RE: THE RESERVE AT JENSEN BEACH – Major Revised Master and Final Site Plan – Second Resubmittal in Response to Staff Report Dated August 19, 2019 (MC Project #S185-012; Lucido #18-021)

Itemized Responses to Staff Report

OPEN SPACE SITE DATA

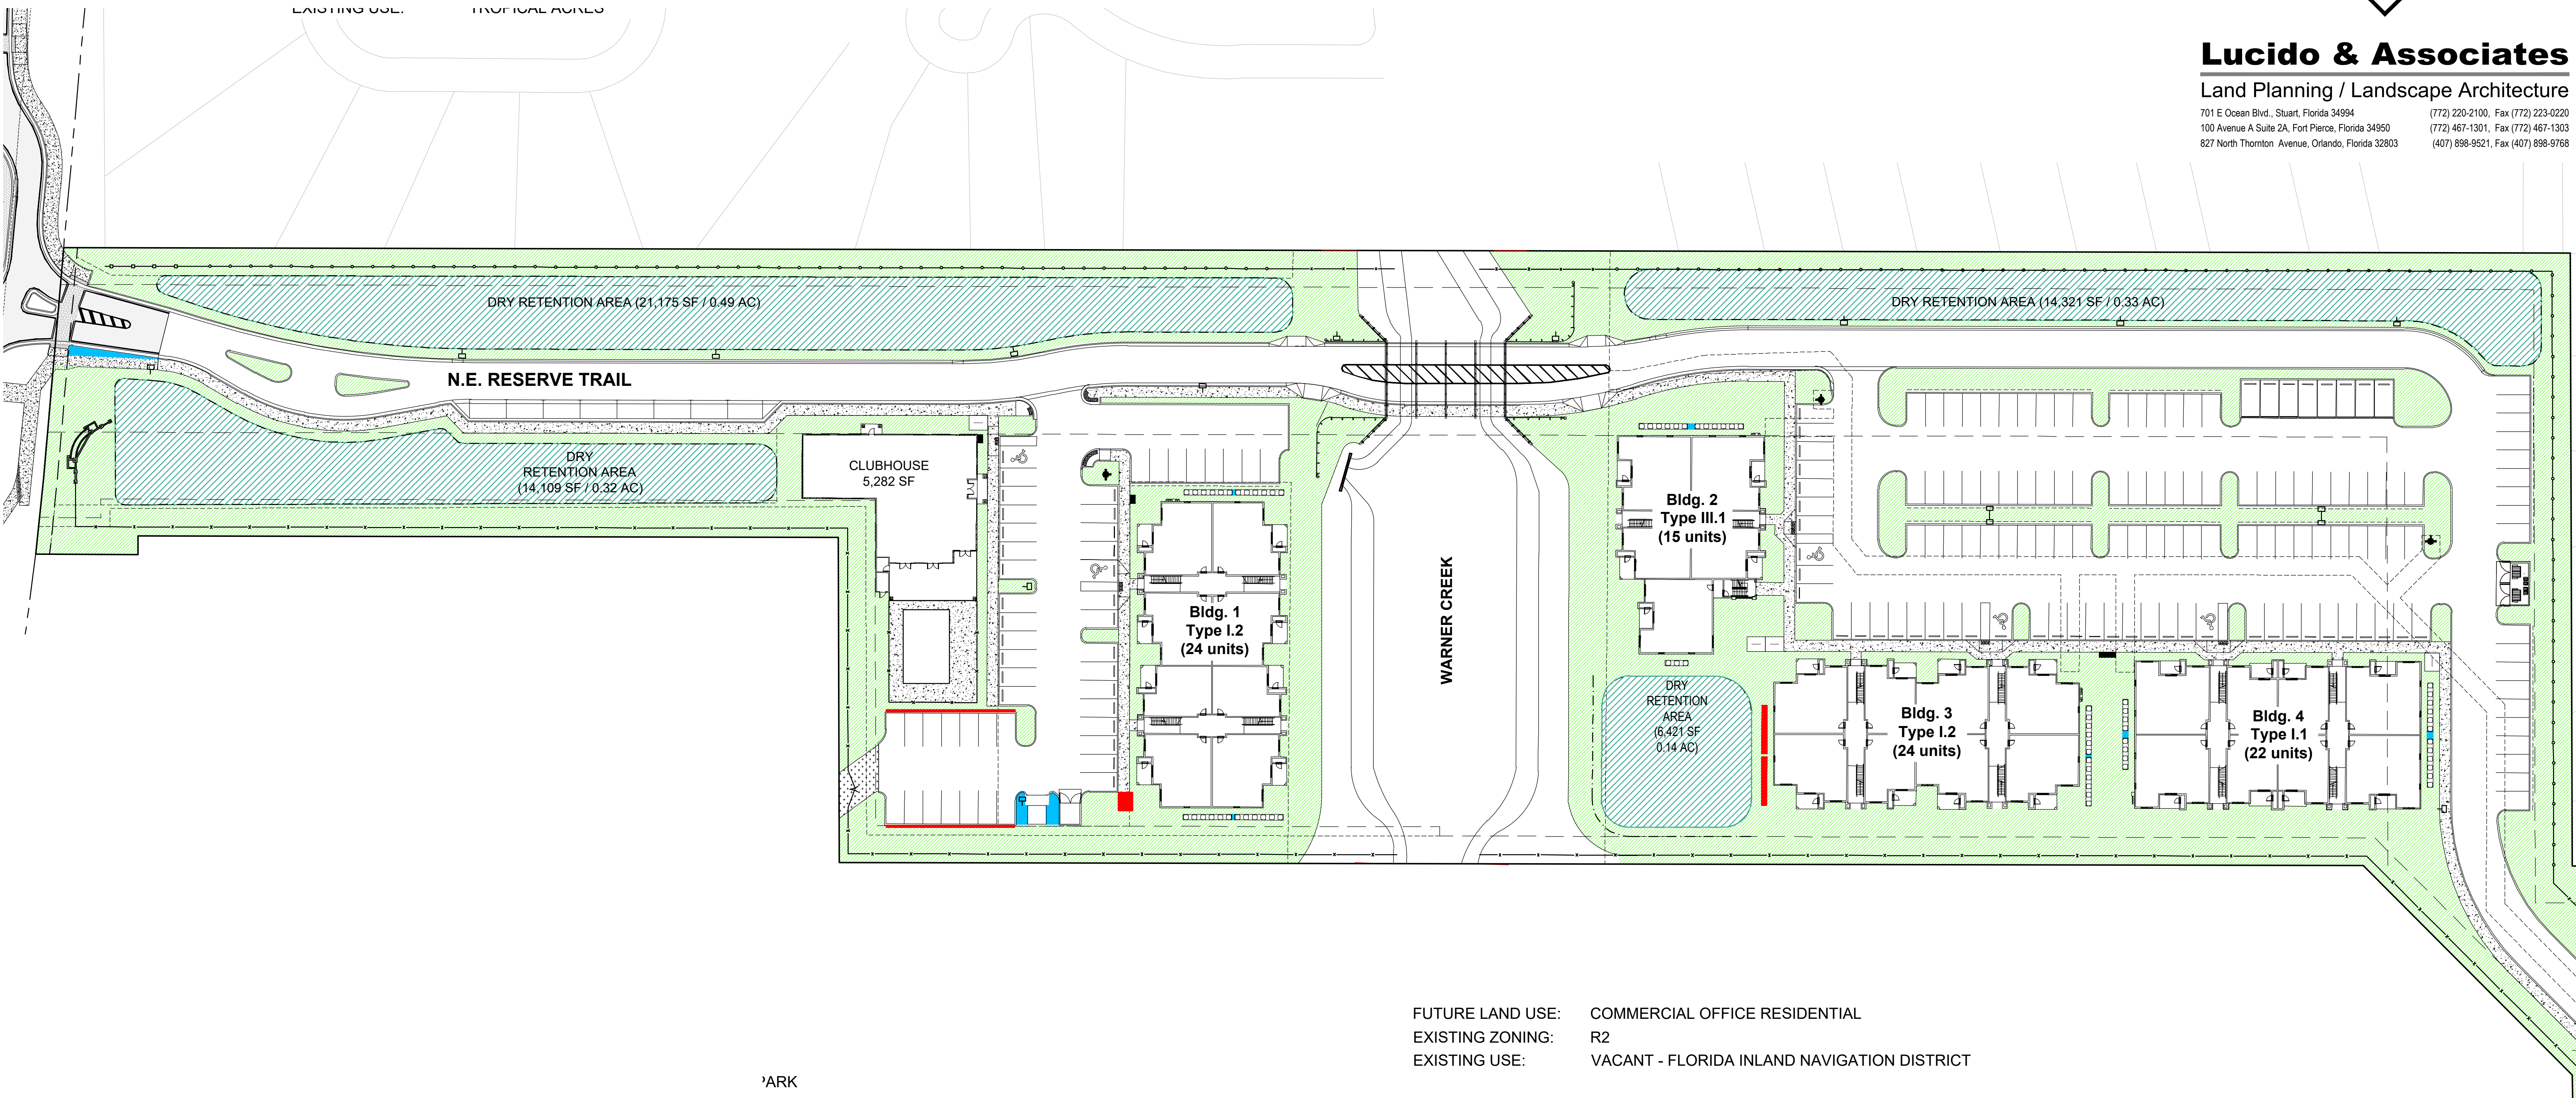
1. The resolution of the open space exhibit, provided on a single sheet without relevant dimensions, is insufficient for staff to be able to confirm the inclusion or exclusion of areas contributing to open space. a. Please submit a revised open space exhibit of sufficient resolution to demonstrate compliance with the open space requirements, similar to the site plan resolution.

b. Please include the relevant dimensions within the graphics, such as 2' dimension in each parking row proposed for vehicle overhangs into pervious area.

c. Please change the graphic fill for landscape areas to a solid color whose extent does not overrun or underrun the related graphic linework, for clarity.

d. Please also provide all data in square feet, in addition to the acreages given. and site data shown on the revised master/final site plan.

2. The open space and the pervious area cited in the site plan data tables are the same. However, the project design and the submitted open space graphic depict areas that are pervious but that do not qualify as open space, so these numbers could not be identical. Please revise the appropriate materials (site plan and/or open space exhibit) for consistency with each other and the proposed buildout conditions.

3. The following areas appear to be ineligible to contribute to project open space but also appear to be proposed to contribute to open space on the open space exhibit. Please revise either the site plan or the open space exhibit for consistency and to eliminate areas that are ineligible consistent with the proposed buildout conditions. Some of the following inconsistencies may be due to the lack of resolution, inappropriate graphic 'green fill', and lack of dimensions on the open space exhibit. (Please see comment #1 above). Although almost all of the proposed parking landscape overhang areas are depicted too ambiguously for verification, due to the provided coloring/fill overspill and the lack of dimensions and resolution, the following areas appear to be non-compliant: a. Parking overhangs in the lot immediately south of the pool,

It was agreed during the workshop discussion that the open space exhibit was sufficient to document compliance with the minimum open space requirement and all agreed that no additional analysis of open space was required or needed. The minor omissions and additions that were identified on the enclosed open space exhibit during the workshop have been reflected correctly on the enclosed master/final site plan site data.

The minor omissions and additions that were identified on the attached open space exhibit during the workshop have been reflected correctly on the enclosed master/final site plan site data.

It was agreed during the workshop discussion that the open space exhibit was sufficient to document compliance with the minimum open space requirement and all agreed that no additional analysis of open space was required or needed. The minor omissions and additions that were identified on the enclosed open space exhibit during the workshop have been reflected correctly on the enclosed master/final site plan site data.
